Groundwater Application Review Summary Form

Application # G- 18532

GW Reviewer Joe Kemper Date Review Completed: 8/29/2023

PUBLIC INTEREST REVIEW FOR GROUNDWATER APPLICATIONS

Figure 2. Well Location Map

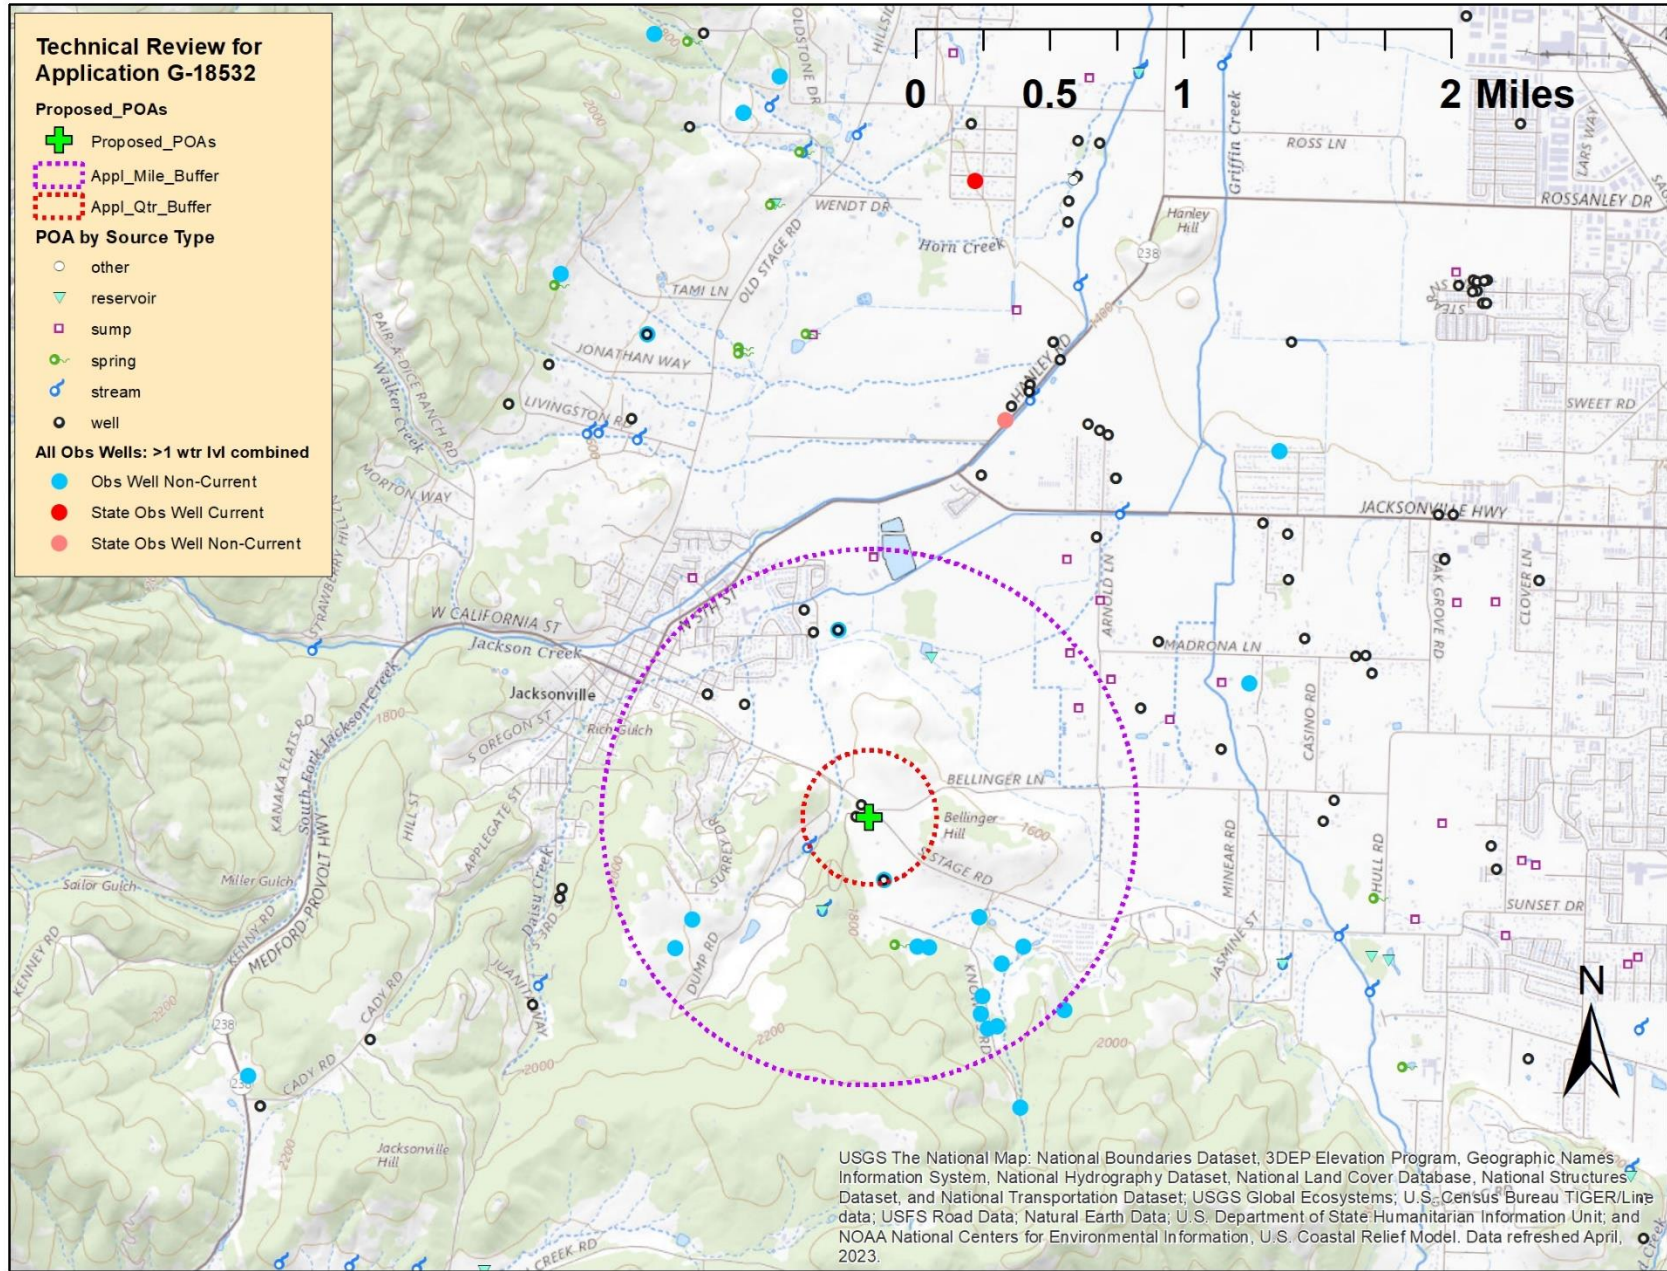
There is moderate groundwater development to the northwest, but considering the requested rate and the nature of the aquifer (decomposed bedrock and local fracture systems), it is unlikely the proposed use will cause injury to senior users. There is a POA located less than 300 feet to the west (GR-2241), but it is located on the same tax lot. There is a likelihood of well-to-well interference, but because they have the same owner, this review does not consider the potential injury or interference to this particular POA.

Figure 3. Water-Level Trends in Nearby Wells

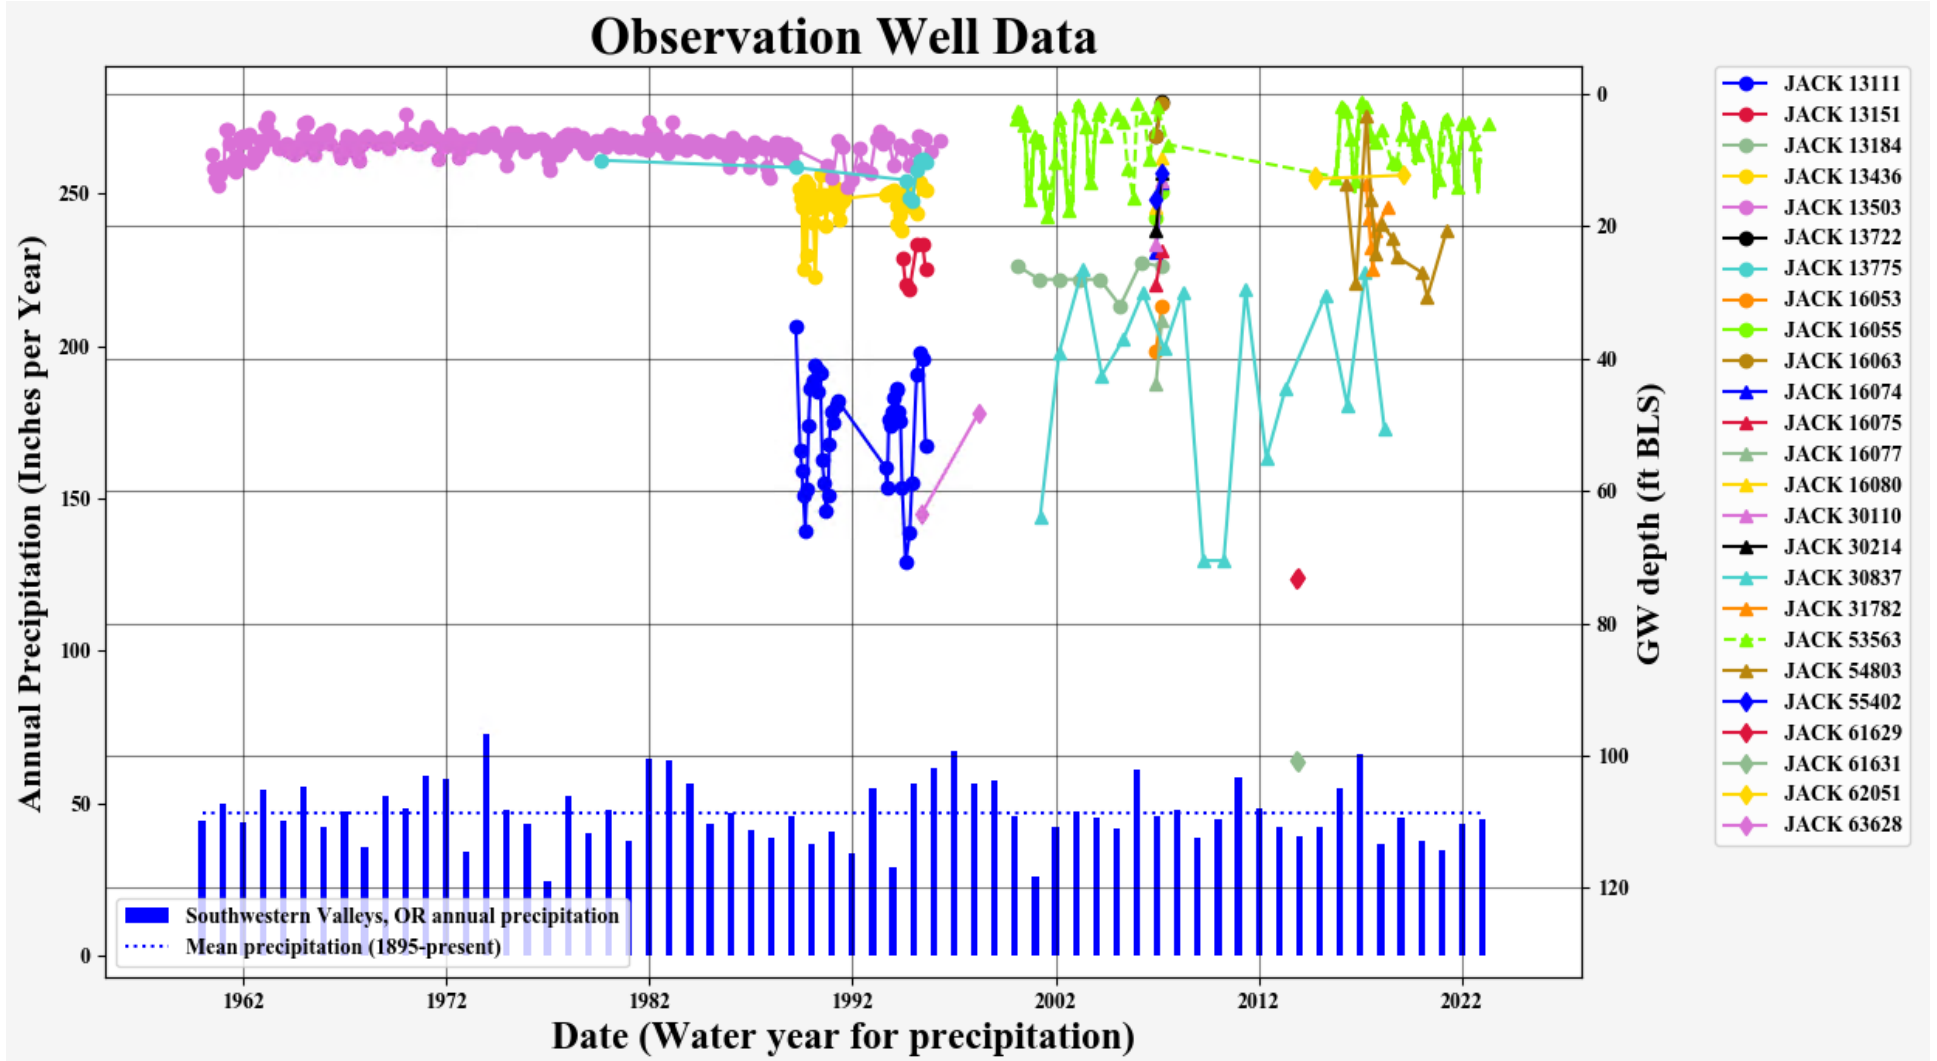
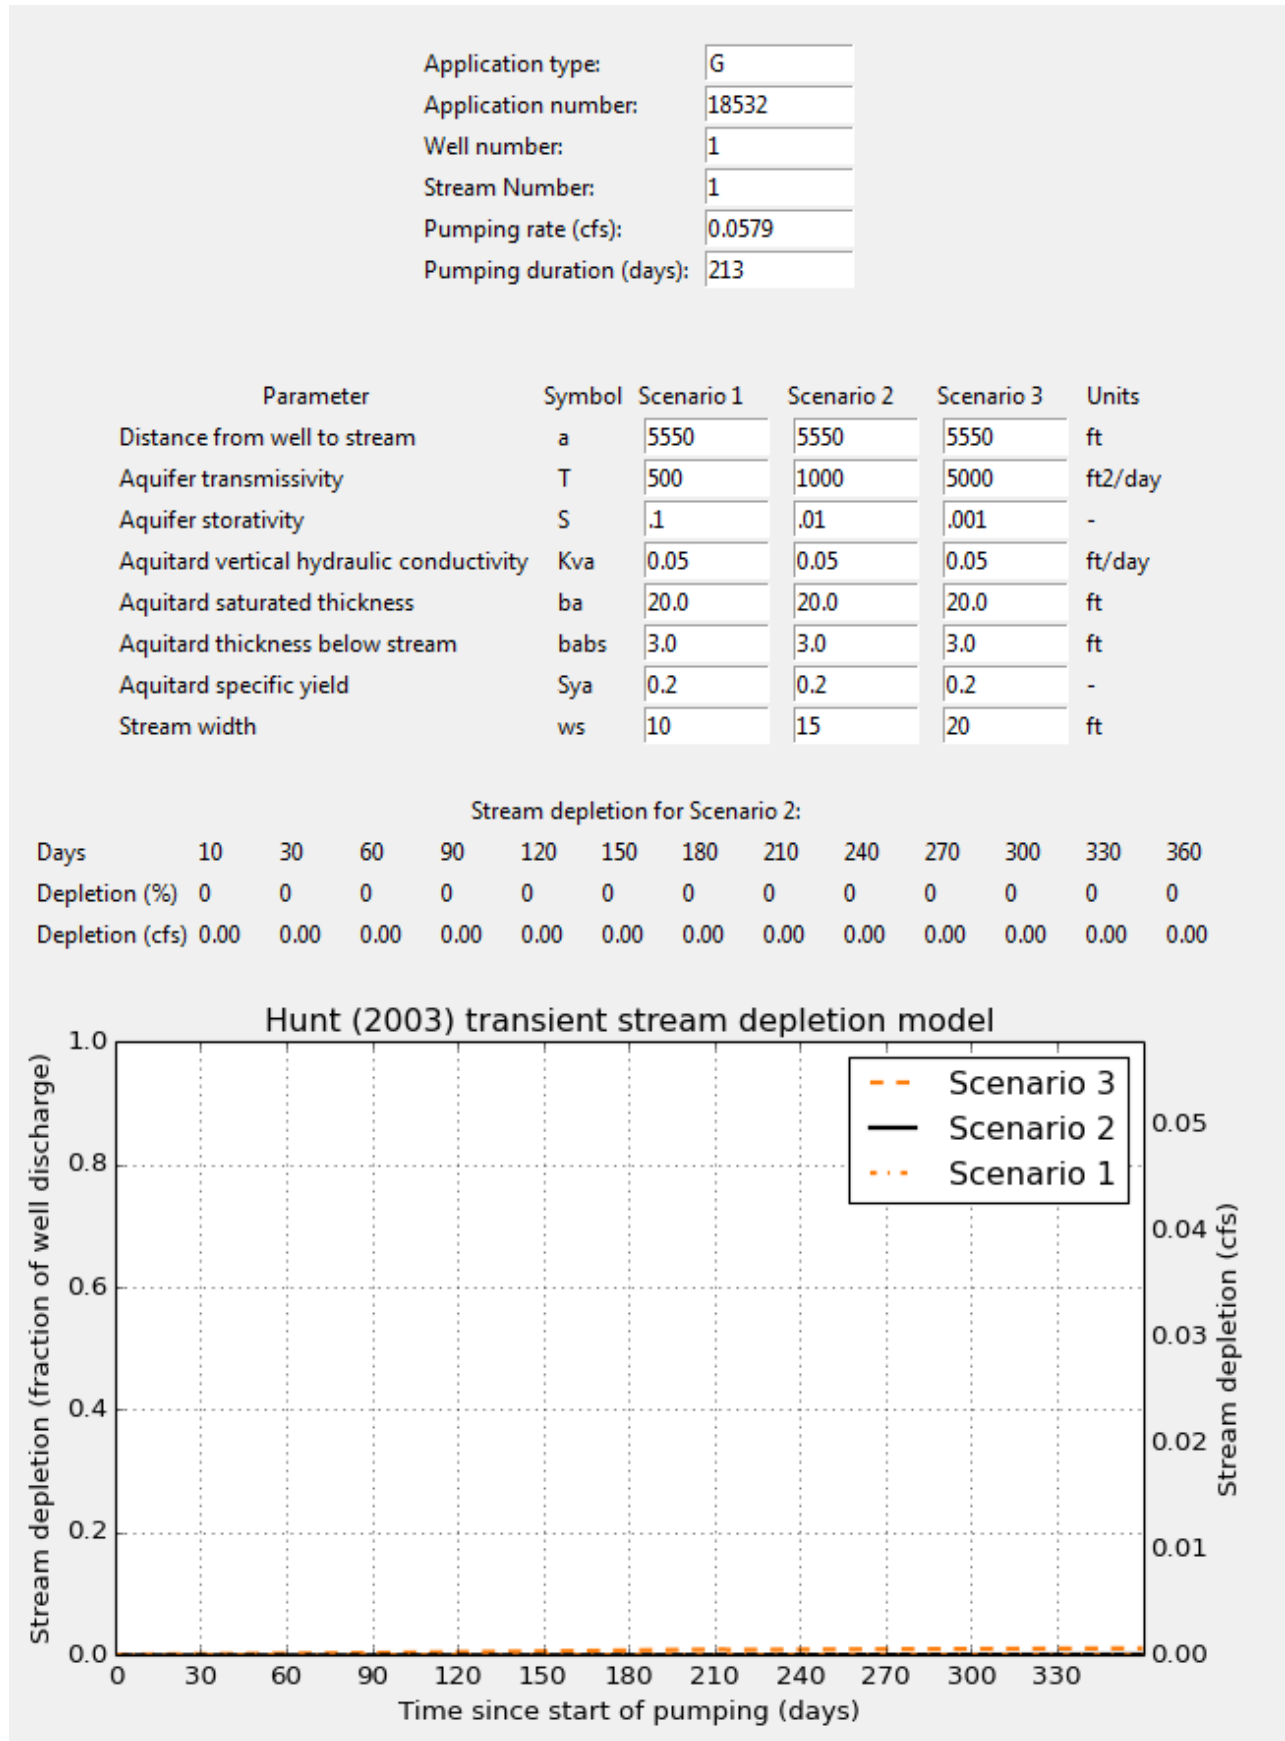
B3. **Groundwater availability remarks:** The applicant’s well would produce from a fractured bedrock aquifer system in metasedimentary units of the Applegate Group. Groundwater level measurements in adjacent observation wells do not show extensive year-on-year declines. Many wells in the fractured-rock aquifers in the Rogue basin located on topographic highs have shown declines in recent dry years, but the applicant’s well sits at the transition to flat lowlands. There are no representative observation wells in the vicinity that show excessive declines. At this time, there is not a preponderance of evidence that the resource is over-appropriated.
